PCN Number:  
24

UF3C120150K3S Obsolescence

# UF3C120150K3S Obsolescence

Measured switching waveforms at 800V-16A, RT

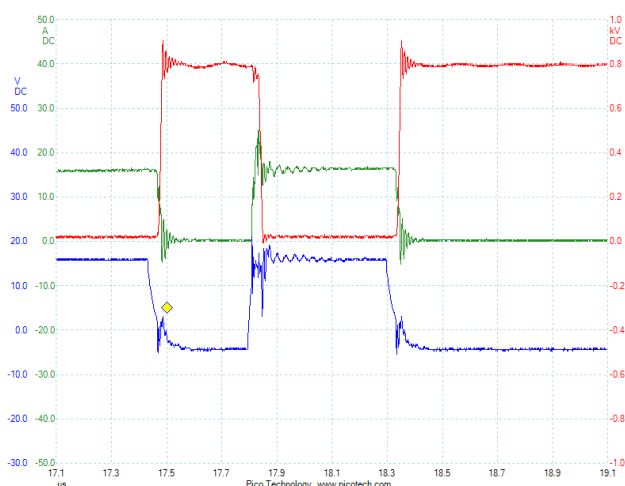
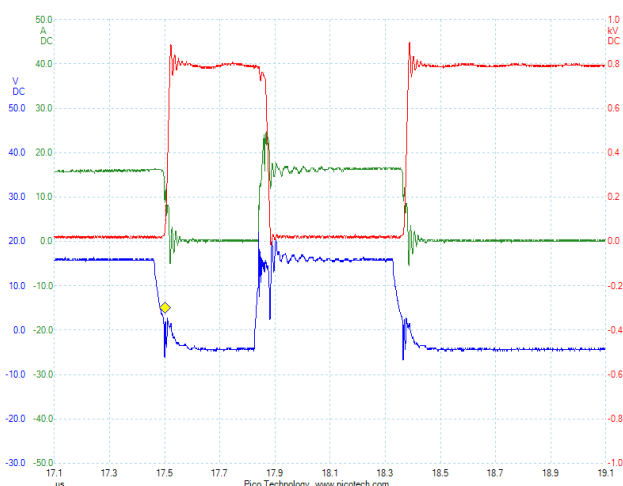
The part was subjected to double pulse testing and was found to ring at turn-on and turn-off, regardless of snubber parameters.

Without device RC snubber  
 $E_{on} = 307\mu\text{J}$   
 $E_{off} = 31\mu\text{J}$

With device RC snubber:  $C_s=47\text{pF}$ ,  $R_s = 5\text{ohm}$   
 $E_{on} = 354\mu\text{J}$   
 $E_{off} = 44\mu\text{J}$

With device RC snubber:  $C_s=94\text{pF}$ ,  $R_s = 5\text{ohm}$   
 $E_{on} = 390\mu\text{J}$   
 $E_{off} = 56\mu\text{J}$

# Replacement Part Option 1: UJ3C120150K3S

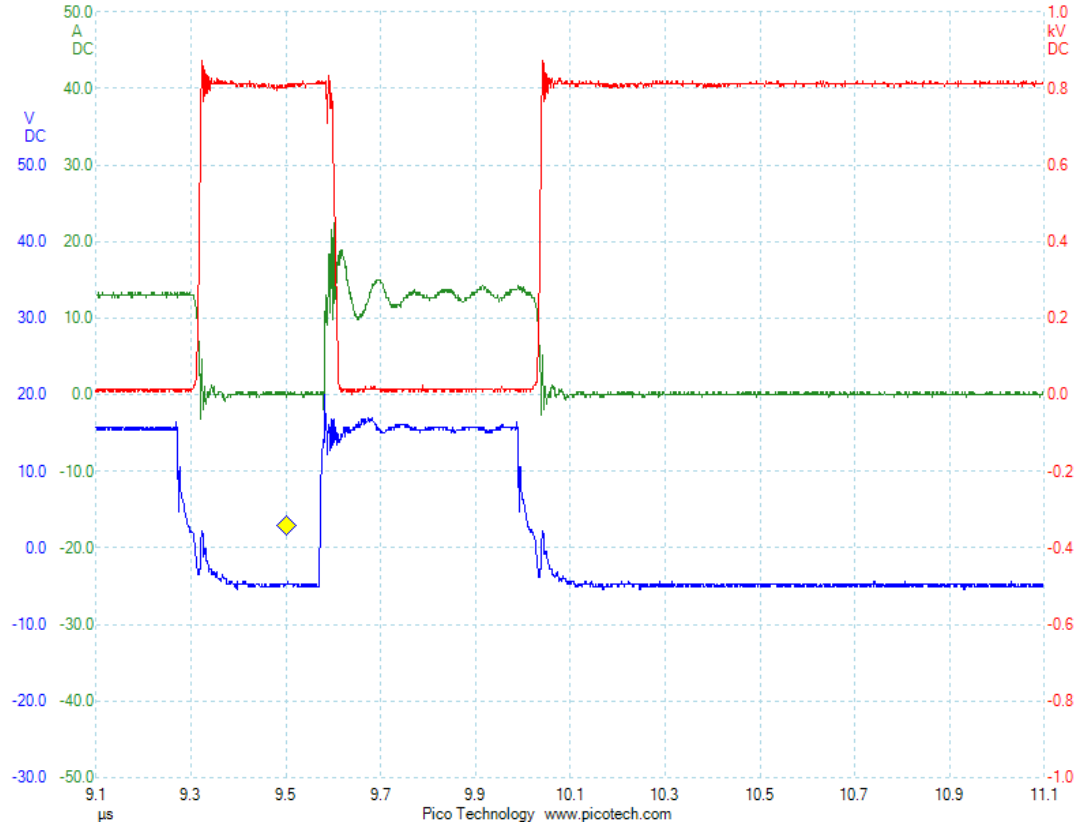
Measured switching waveforms at 800V-13A, RT, with  $R_{g,on} = 1\Omega$ , and  $R_{g,off} = 20\Omega$

The Turn-on and Turn-off ringing can be reduced with the correct snubber parameters.

## Replacement Part Option 2: UF3C120150K4S

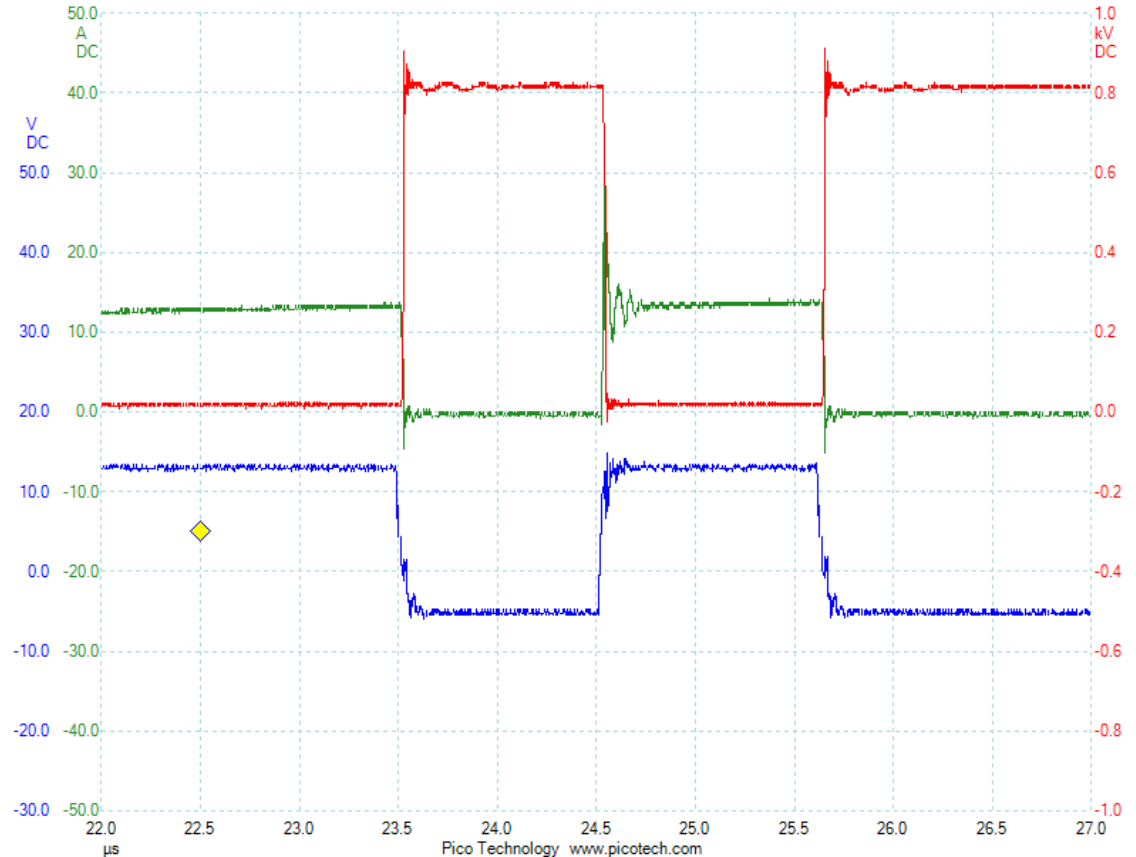
Measured switching waveforms at 800V-13A, RT, with  $R_{g,on} = 15\Omega$ , and  $R_{g,off} = 22\Omega$

The Turn-on and Turn-off ringing can be reduced with the correct snubber parameters.
